Contract Description

CP6 – Return Flow Pipeline, 18-in Sanitary Sewer and Outfall Facilities | 199990-CP6
Change Order Request No. 005 | 80.1725
MEMORANDUM

Subject: Change Order Request No. 005 Response
Westridge Drive - Depth and Alignment Changes

Re: Waukesha Water Utility – Great Lakes Water Supply Program
Project 199990-CP6 – Return Flow Pipeline
Request for Information 0038 & 0045 – Change Proposal (Westridge Drive & Mooreland Road)

1 CORNER REINFORCING DETAIL
SCALE: 3/8" = 1'-0"

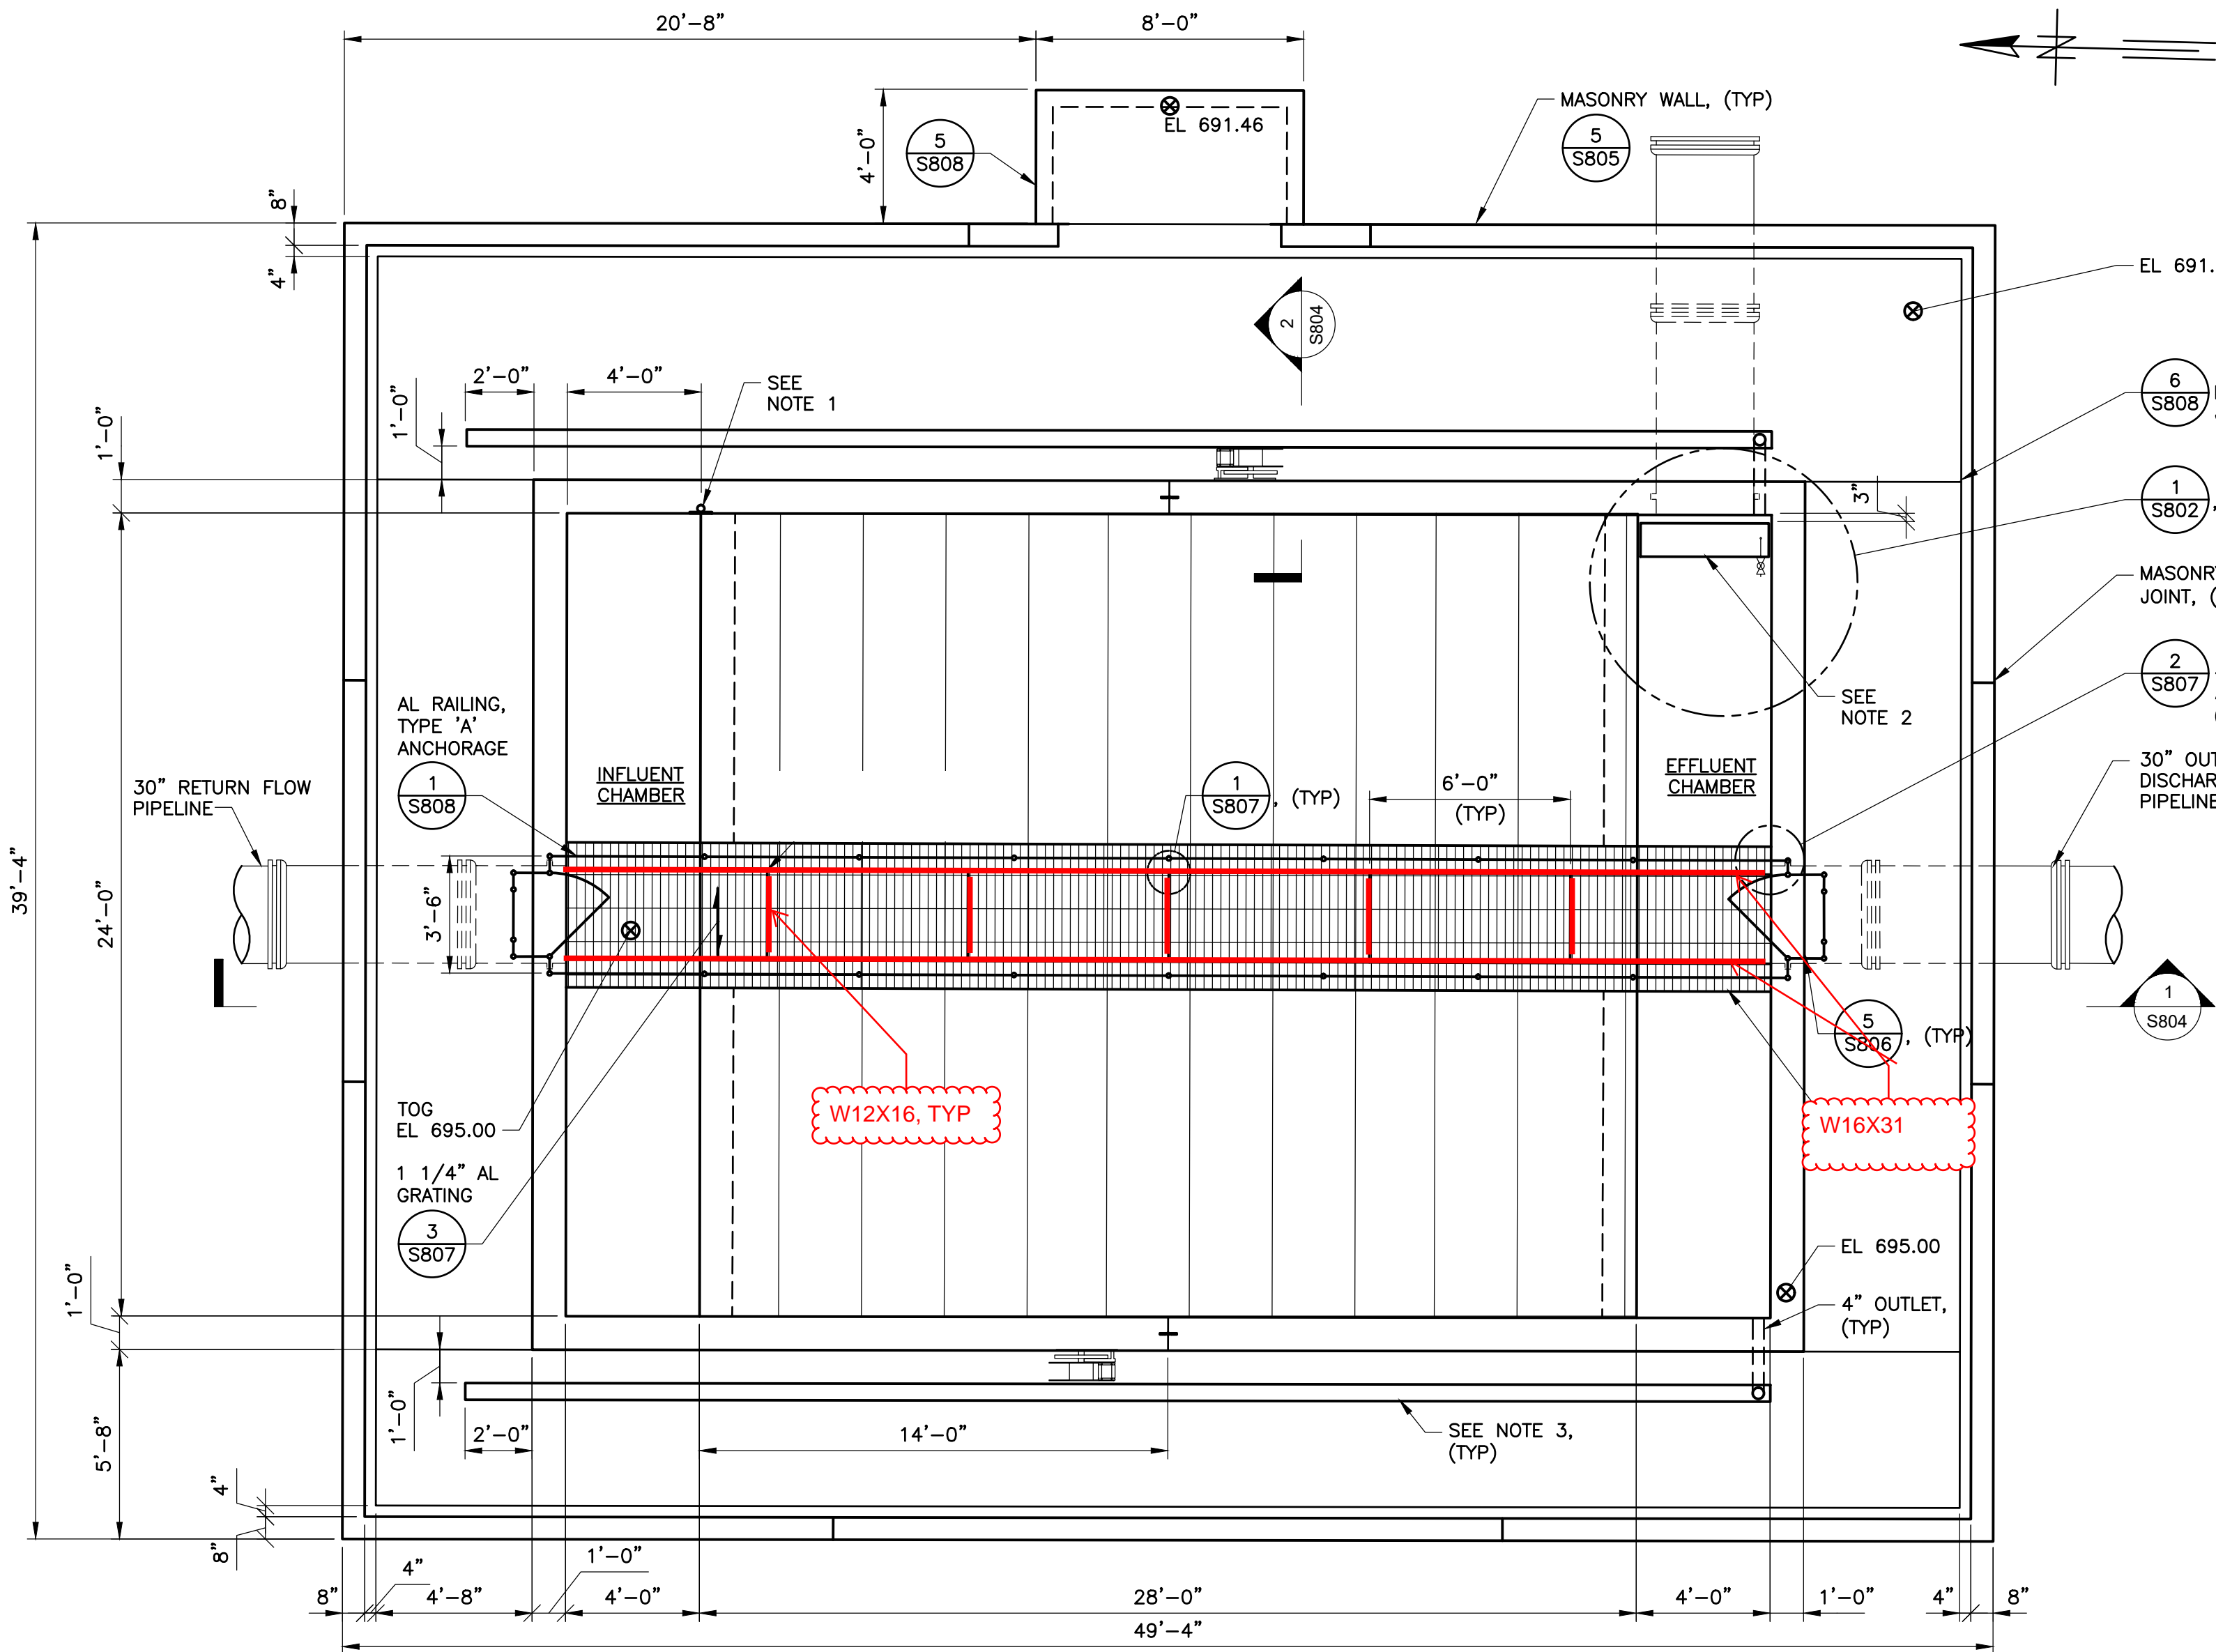
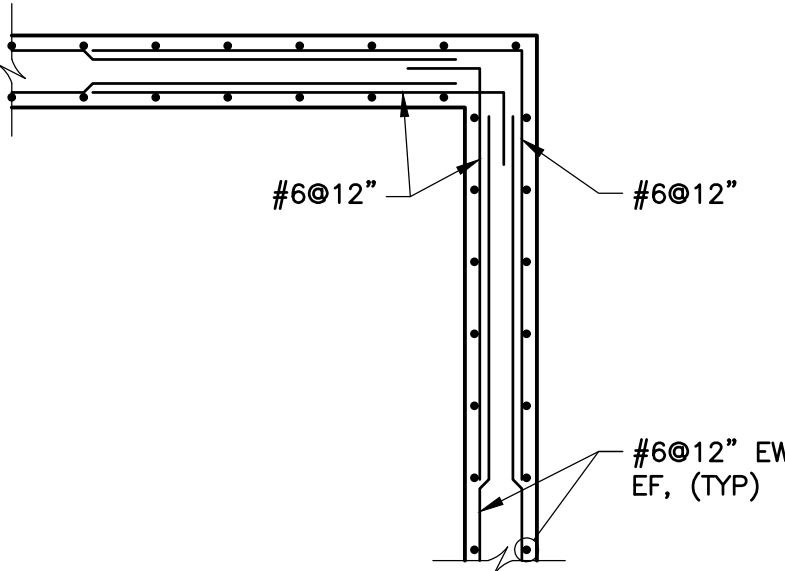
MEMBER SIZES ARE PROVIDED FOR PRICING AND AVAILABILITY COMPARISON BETWEEN GALVANIZED STEEL AND TYPE 304 STAINLESS STEEL.
